### 142.2.4 FEC encoder

#### 142.2.4.1 Low Density Parity Check density parity check coding

**Figure 142-6—FEC encoder**

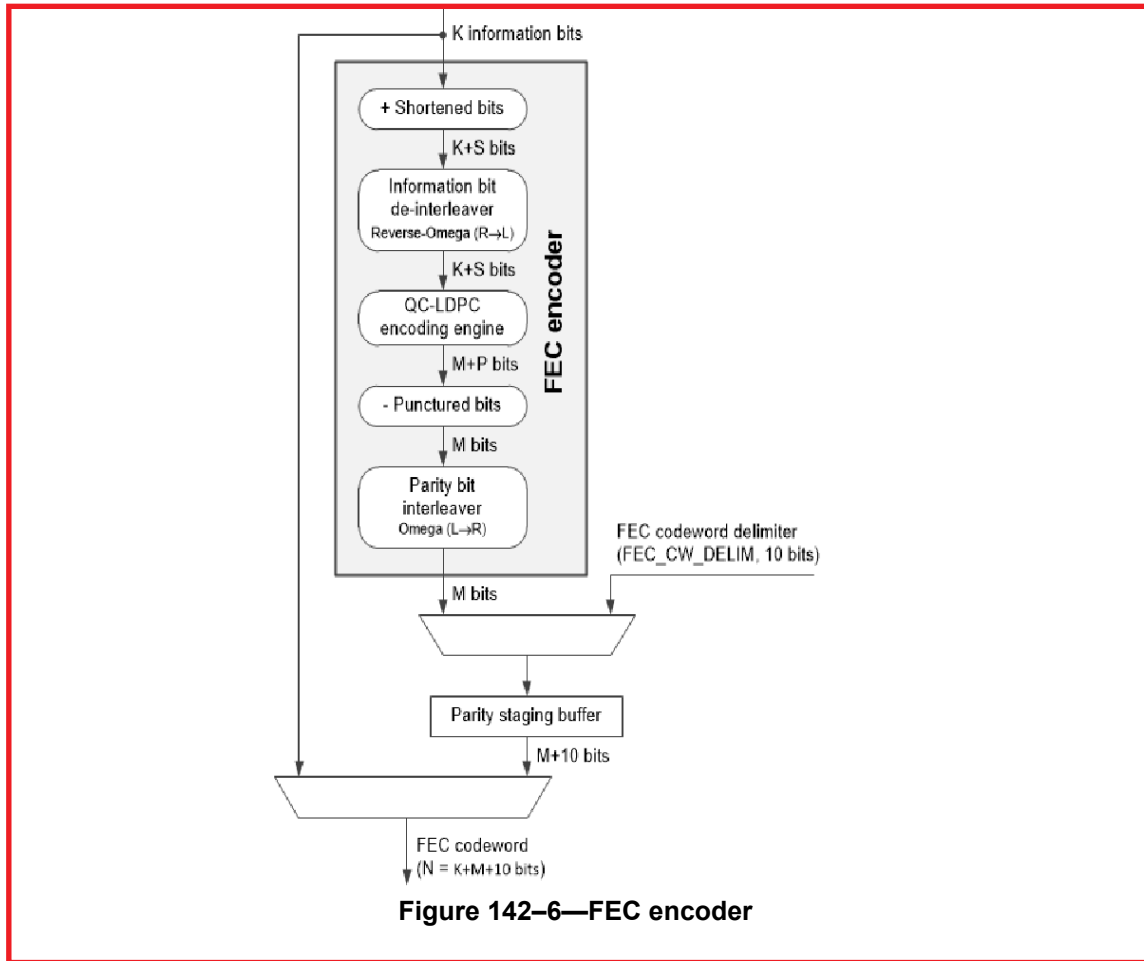
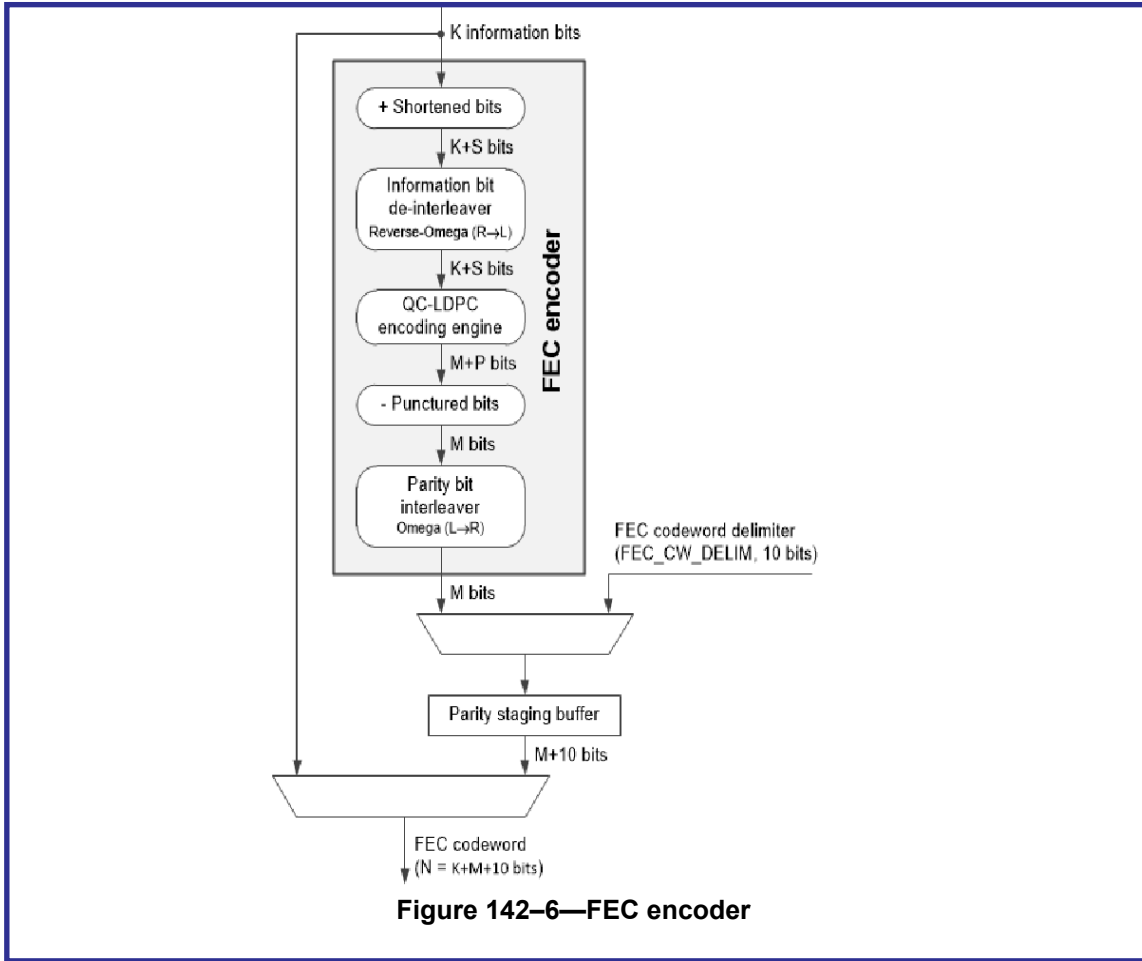
The FEC encoder is shown in Figure 142–6. The encoder consists of a systematic QC-LDPC encoding engine followed by a shortening and puncturing mechanism and the addition of a 10-bit delimiter. The parameters of the FEC encoder are:

The LDPC encoder as shown in Figure 142-6 places the  $M$ -bit FEC parity bits into the *ParityStagingBuffer* for use by the PCS Transmit Process (see 142.2.5.4.3) and the *FecParity()* function. The buffer is comprised of 2560 bits of calculated parity along with the 10-bit codeword-delimiter (*FEC\_CW\_DELIM*). This results in the parity bits assigned to *ParityStagingBuffer*<2559:0> and the 10-bit *FEC\_CW\_DELIM* value to *ParityStagingBuffer*<2569:2560>. The transmission order starts with bit 0 and ends with bit 2569.

The LDPC encoder in Figure 142–6 places the  $M$ -bit FEC parity bits into the *ParityStagingBuffer* for use by the PCS Transmit Process (see 142.2.5.4.3) and the `FecParity()` function. The buffer is comprised of 2560 bits of calculated parity along with the 10-bit codeword delimiter (FEC\_CW\_DELIM). This results in the parity bits assigned to *ParityStagingBuffer*<2559:0> and the 10-bit FEC\_CW\_DELIM value to *ParityStagingBuffer*<2569:2560>. The transmission order starts with bit 0 and ends with bit 2569.
